Subject: Response To Request For Additional Information – License Amendment Request No. 283 Control Room Habitability (TAC NO. MB0906)

Oyster Creek Generating Station (Oyster Creek)  
Facility Operating License No. DPR-16  
NRC Docket No. 50-219

**RESPONSE TO REQUEST FOR ADDITIONAL INFORMATION –  
RADIOLOGICAL CONSEQUENCE ANALYSIS  
FOR CONTROL ROOM OPERATORS**

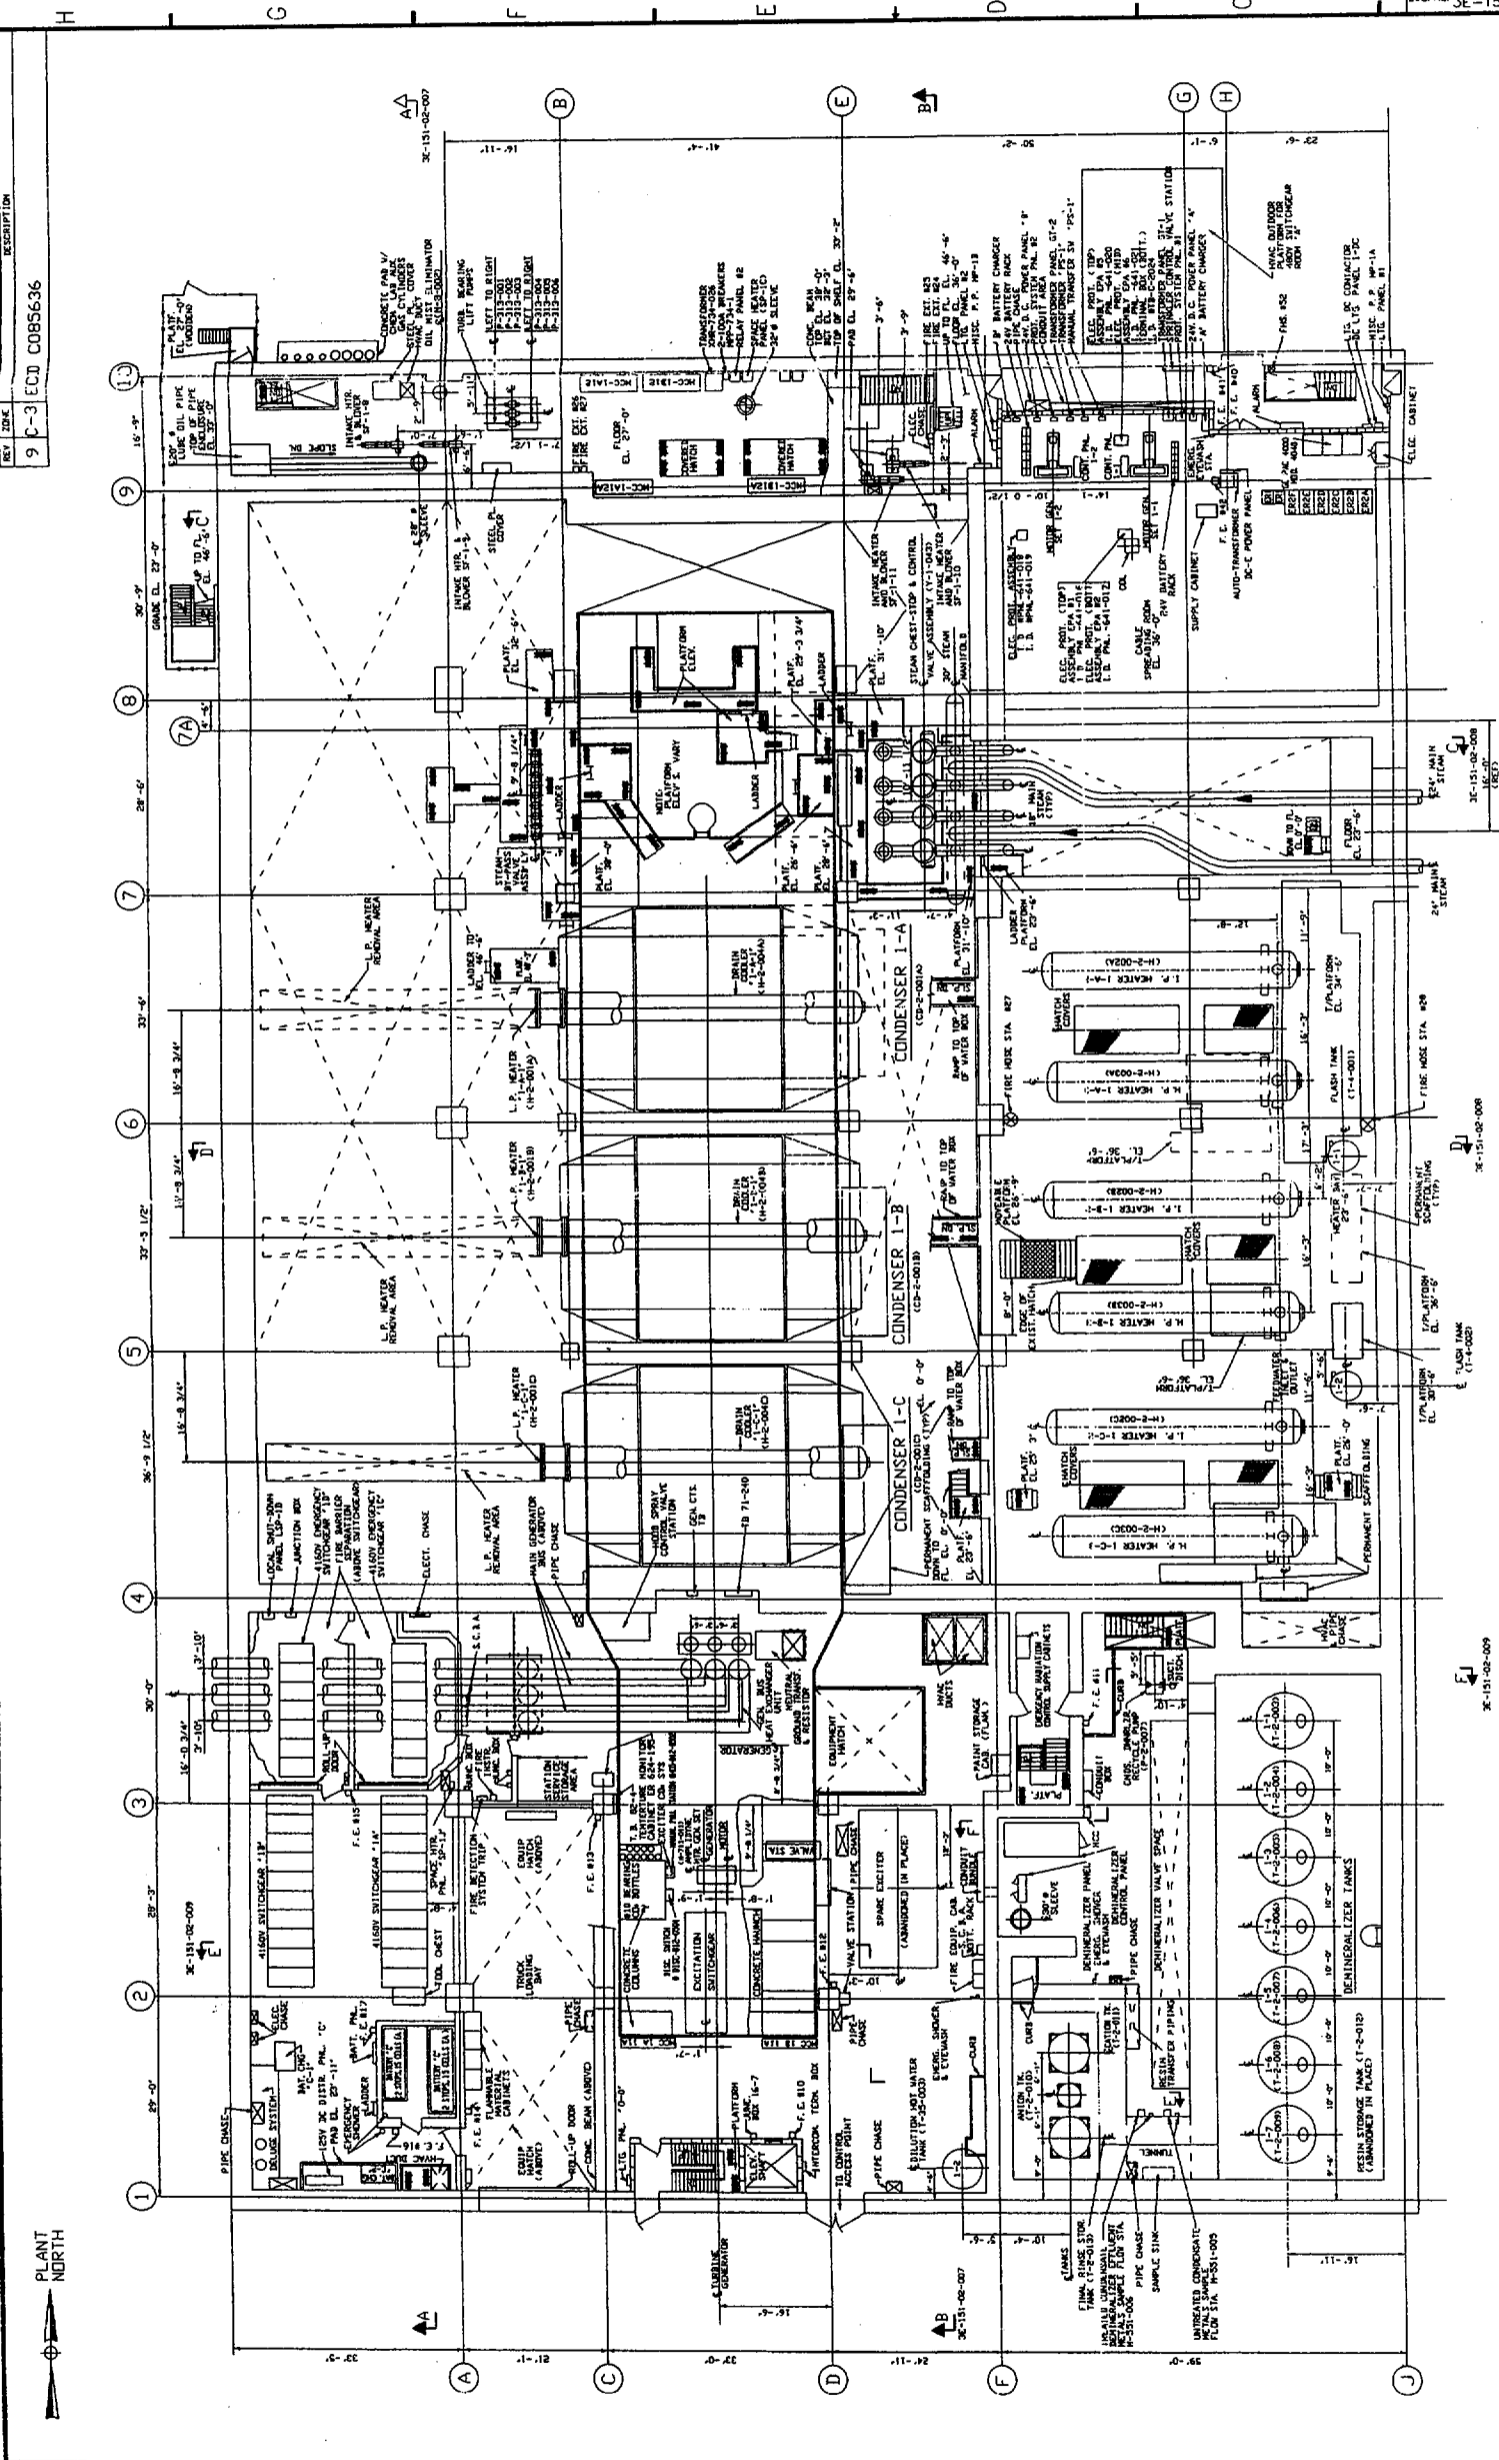
What assurance is there that the effluent will leak out over the surface of the turbine wall or an equivalent area rather than from some other location, such as the turbine building vent closest to the control room intake?

All MSIV leakage release is conservatively assumed to exit the East turbine building wall. This is conservative because this pathway is closer to the air intake for turbine building release.

Figure 1 Site Plot Plan showing principal release points

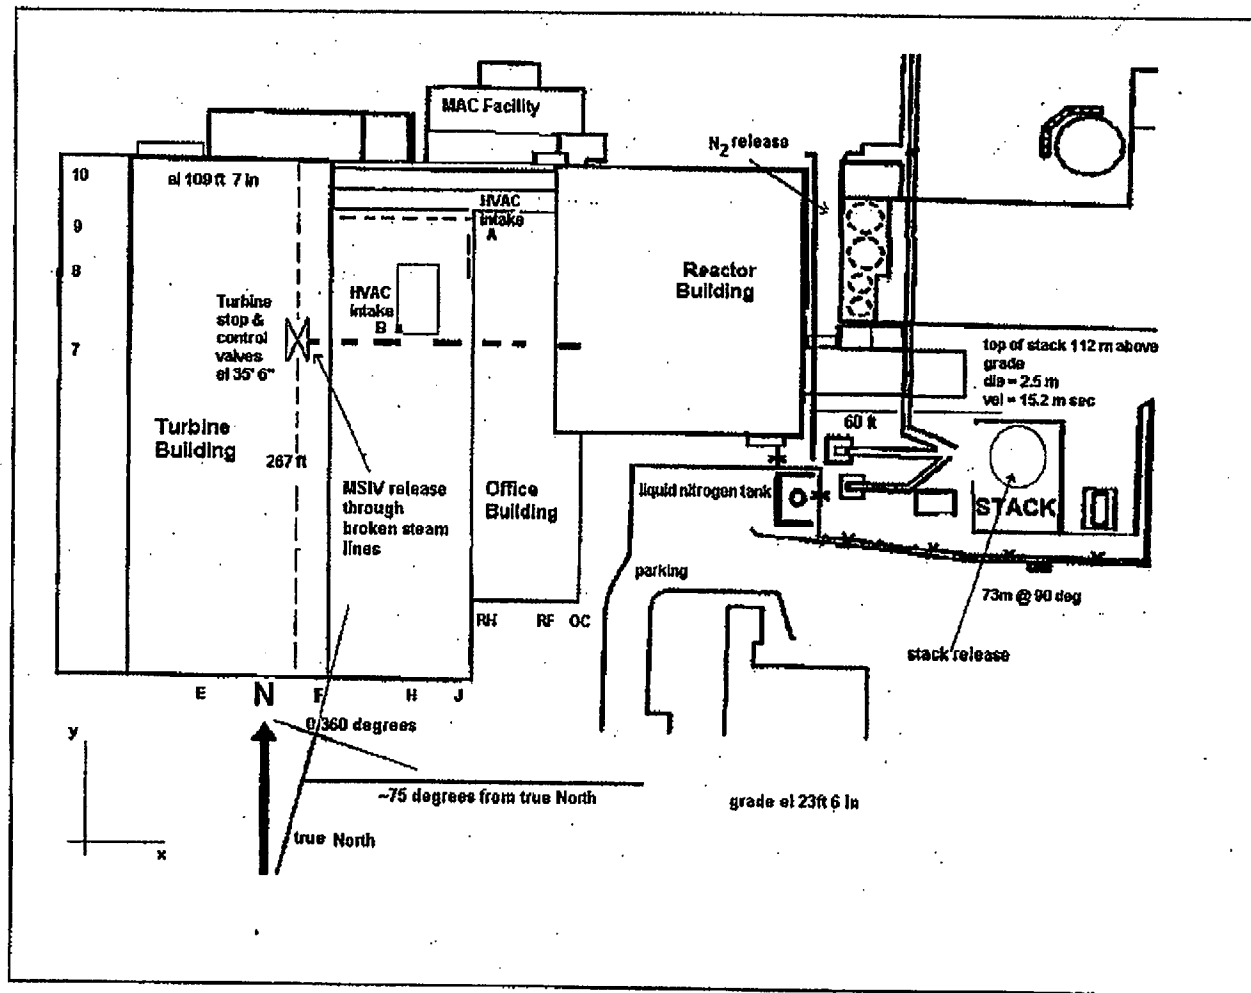
Provide or reference plant drawings in the Safety Analysis Report or elsewhere that show the relationship between potential release locations from plant systems to the environment and from the environment to the control room intake with respect to distances, structural dimensions, and directions from true north.

Plant drawings referenced in the above responses to NRC Questions 2 and 3 show the relationship between potential release locations from the MSIVs to the environment. Figure 1, in the enclosed Calculation No. C-1302-826-E540-017, provides the distances and directions from true north for the MSIV leakage release and the N<sub>2</sub> line release to the "B" air intake.
